Safety Evaluation Report
Renewal of the Facility Operating
License for the TRIGA Nuclear
Reactor at Reed College

U.S. Nuclear Regulatory Commission

April 2012

Figure 2-6 GA-7882, confirmatory, and RRR fuel temperature coefficients

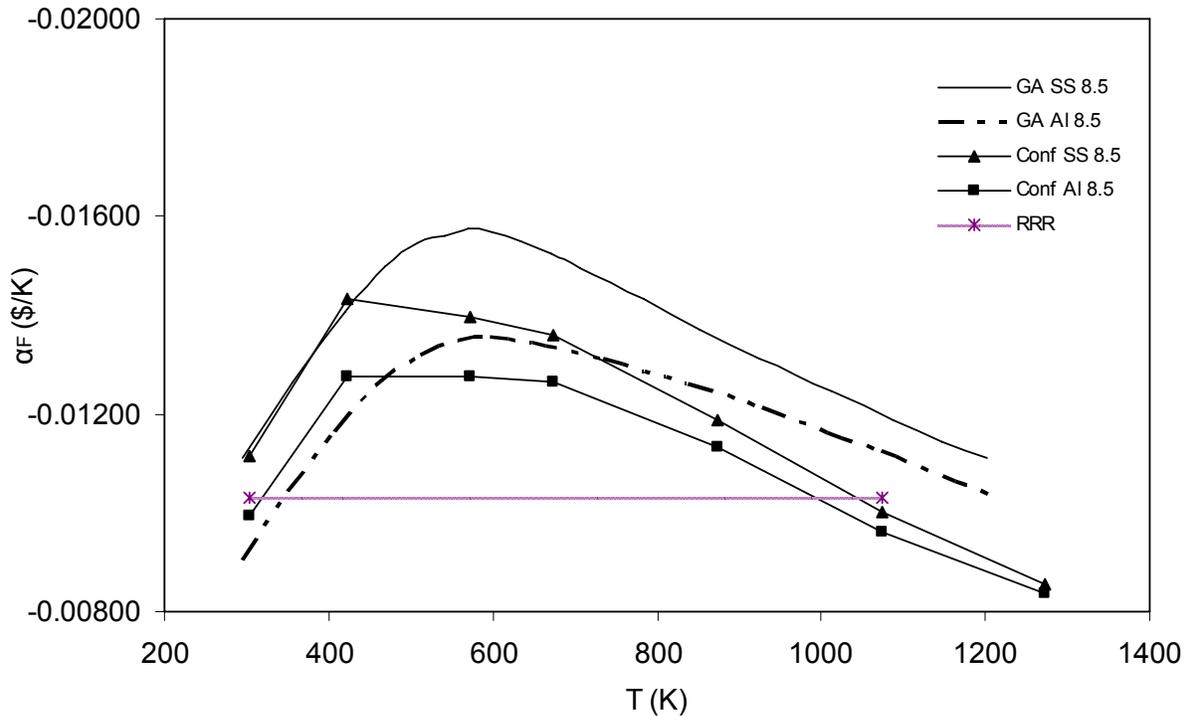
The reference GA results, NRC staff confirmatory results, and RRR's chosen value of -0.0103 \$/K, are displayed on Figure 2-6 above. The NRC staff finds that the FTC value the licensee selected, -0.0103 \$/K, provides less negative reactivity feedback than is physically available in the reactor; therefore, it is conservative for the safety analyses results. On the basis of the information provided above, the NRC staff concludes that the RRR FTC is, therefore, acceptable.

Figure 2-7 Uncontrolled rod withdrawal

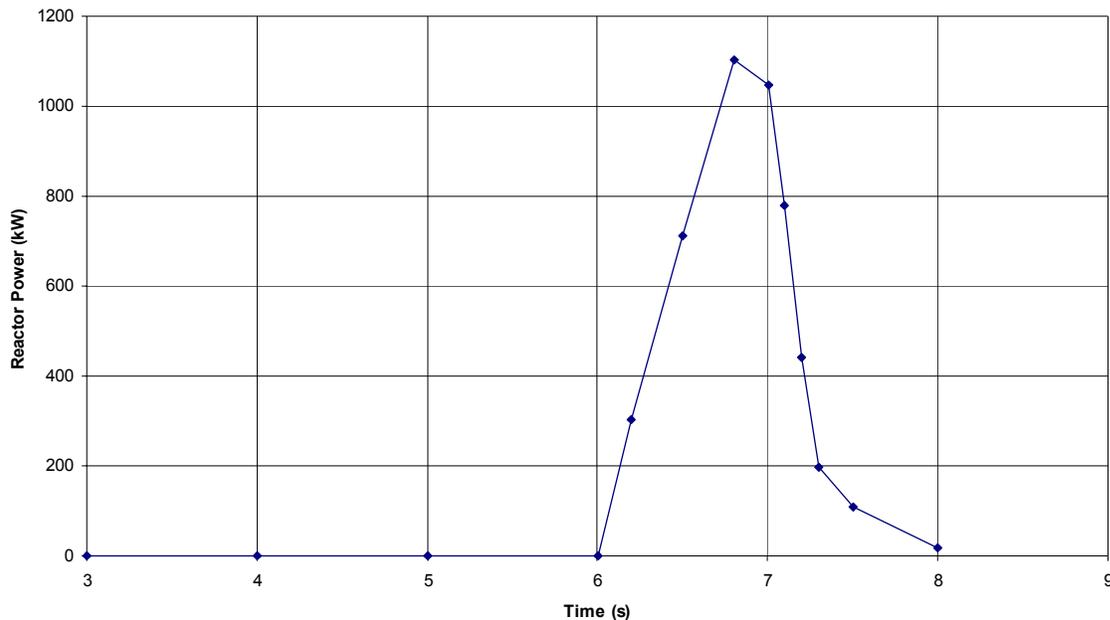
The scram signal occurs at 6.5 seconds at a power of 285 kW. Power continues to rise until the delay time is exhausted. At this time the peak power of 1,103 kW is attained very briefly. Because nuclear processes occur much more rapidly than thermal-hydraulic processes, the peak fuel temperature, which begins the transient at ambient temperature (25 degrees C), peaks at 51 degrees C. The results are shown in Figure 2-7.

The NRC staff finds that the peak power reached, for a very short time, does not pose a challenge to the fuel temperature SL or the DNBR because the time duration is extremely fast and the heat transfer so low that it cannot result in any appreciable temperature increase. Consequently, the confirmatory analysis substantiates the licensee's values provided in TS 3.2.1, Specification b, of 1 second for the control rod scram insertion time, and TS 3.2.1, Specification c, of \$0.16/s for the control rod withdrawal rate limit (see Section 2.2.2 of this SER).

Figure 2-10 Maximum fuel temperature as a function of fuel element power

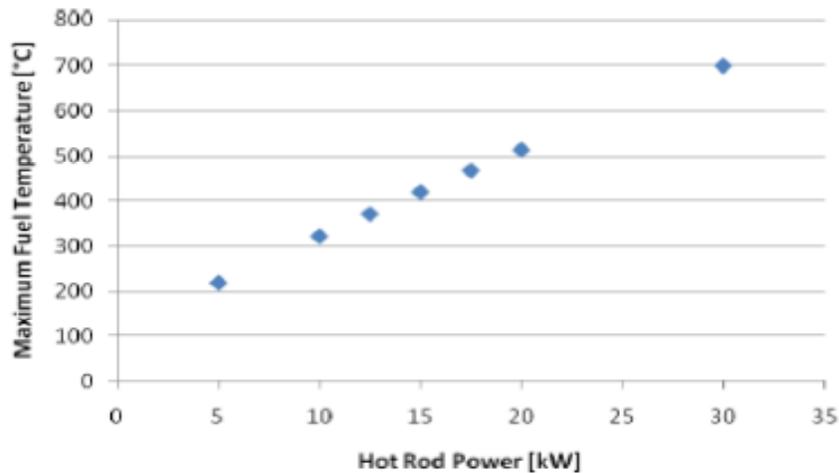
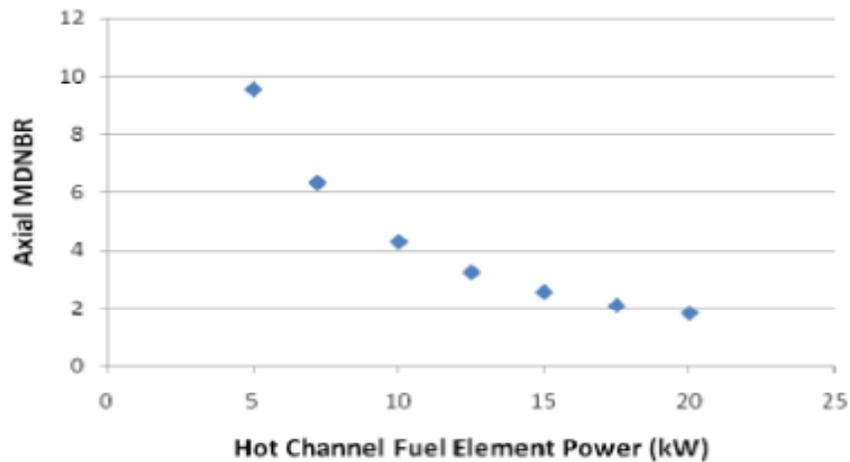
Figure 2-10 and Figure 2-11 illustrate that the RRR can be operated with an acceptable DNBR and at a fuel temperature below the TS 2.1 SL value of 1,000 degrees C. The RRR LCC minimum DNBR was calculated to be 6.33 at the maximum fuel temperature of 264 degrees C at 250 kW steady-state operation. The guidance in NUREG-1537 recommends a minimum DNBR of 2; therefore, the RRR minimum DNBR of 6.33 is well above the minimum DNBR value. The RRR DNBR was consistent with the values reported for other TRIGA research reactors with similar operating power levels.

Figure 2-12 TRACE model of the RRR

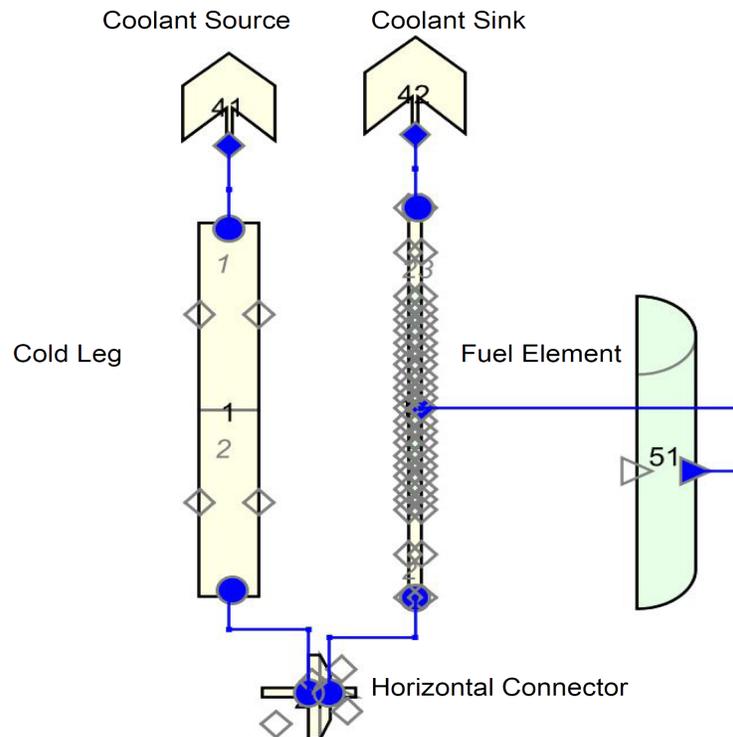
The NRC staff confirmed the calculation of the RRR DNBR using the TRACE computer code (Ref. 20). The model developed is displayed in Figure 2-12.

The TRACE model used the corrected physical characteristics from the RRR SAR and the Bernath correlation. The results of the two models provided acceptable agreement. The

TRACE model DNBR was 6.08, while the RRR DNBR value was 6.33. Figure 2-13 illustrates the reactor analysis at various power levels to develop the natural circulation flow and heat transfer characteristics important to the results.

Figure 2-14 Comparison of confirmatory and RRR DNBR results

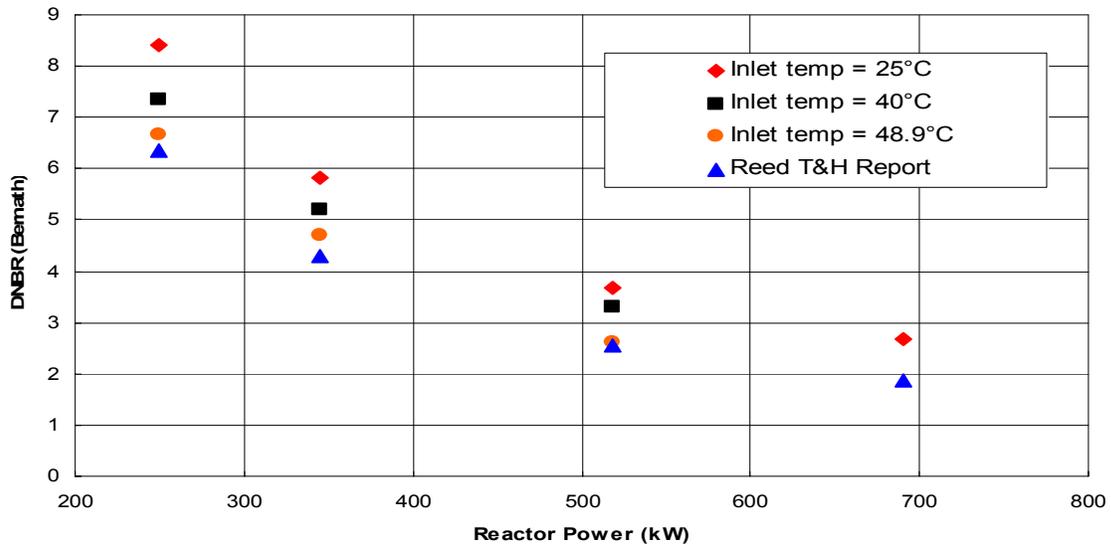
Figure 2-14 displays the TRACE calculated DNBR values as a function of reactor power. The calculations were performed using nominal inlet temperature (25 degrees C) and the TS limit on bulk pool temperature (40 degrees C) from TS 3.3, Specification b. The results illustrate acceptable agreement between the RRR thermal-hydraulic analyses using RELAP3-D and the confirmatory calculation results by the NRC using TRACE.

The NRC staff finds that the RRR thermal-hydraulic analysis for the RRR core adequately demonstrates that RRR can operate at the licensed power level of 250 kW with sufficient thermal-hydraulic safety margins. Furthermore, the NRC staff finds that its independent calculational results of the thermal-hydraulic analysis for the RRR provide a high level of confidence that RRR thermal-hydraulic match the actual core conditions at the licensed power level of 250 kW. Based on the information provided above, the NRC staff concludes that the RRR thermal-hydraulic analysis is, therefore, acceptable.

Figure 1 Administrative Structure

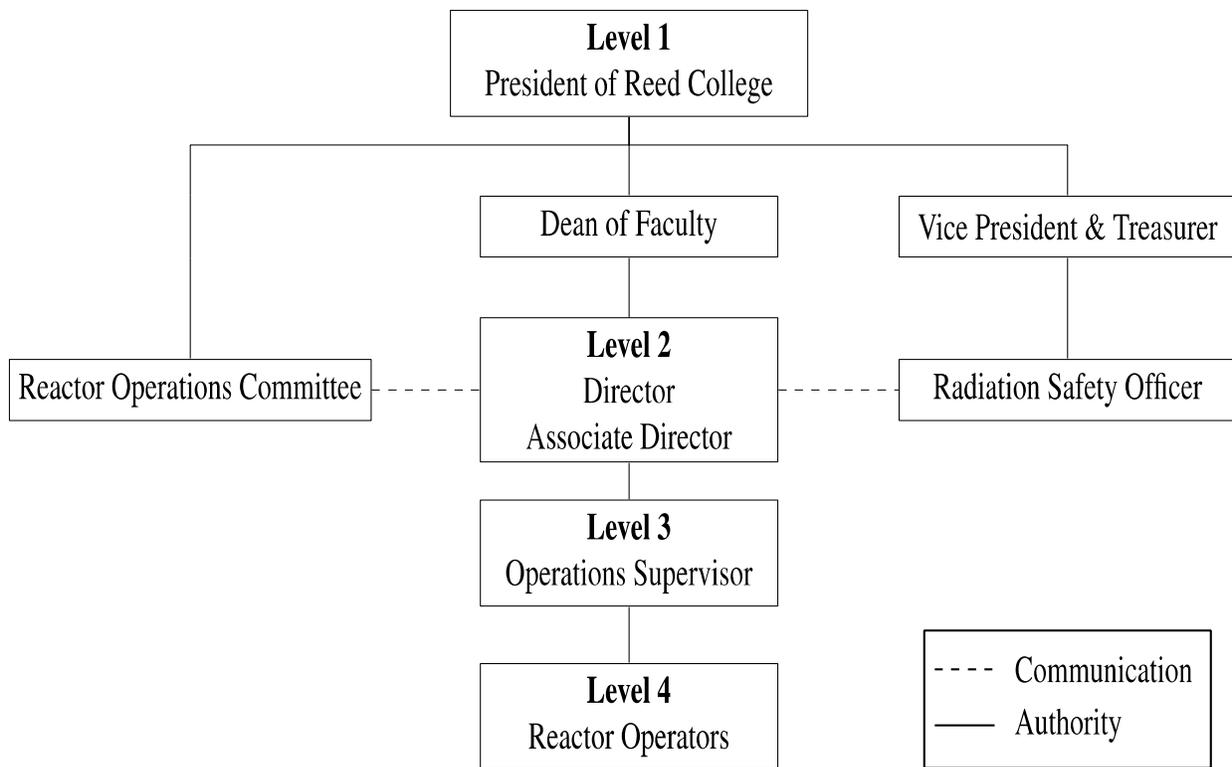
The NRC staff finds that the organizational structure described in TS 6.1.1 is consistent with the guidance in ANSI/ANS-15.1-2007 and NUREG-1537. On this basis, the NRC staff concludes that TS 6.1.1 is, therefore, acceptable.
